## Change Note of DFR0524 V2.0

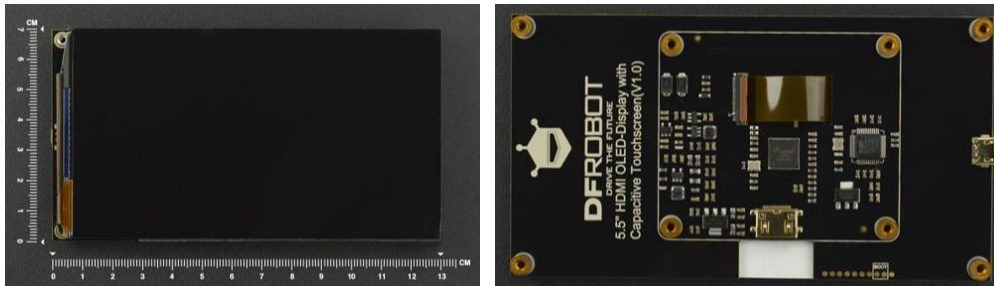
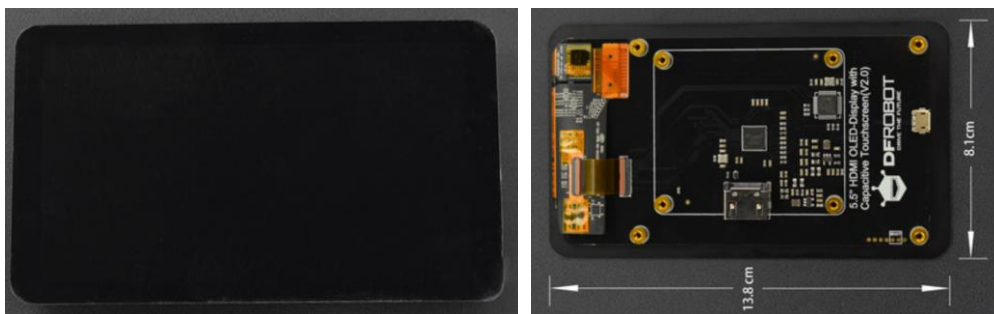
1. Dimension and Mount Holes  
Please kindly note that V1.0 and V2.0 is different in dimension and mount hole position.
2. Screen  
There is no cover in the surface of V1.0.  
While V2.0 is covered by a tempered glass to protect the screen from external force damage.
3. HDMI Socket  
V1.0 adapts HDMI- type C  
V2.0 adapts HDMI- type A
4. Power Supply  
V1.0 support HDMI or USB port power supply, while HDMI socket is limited in charging which may lead to unstable power supply.  
To guarantee stable voltage and current, V2.0 only support USB port power supply.
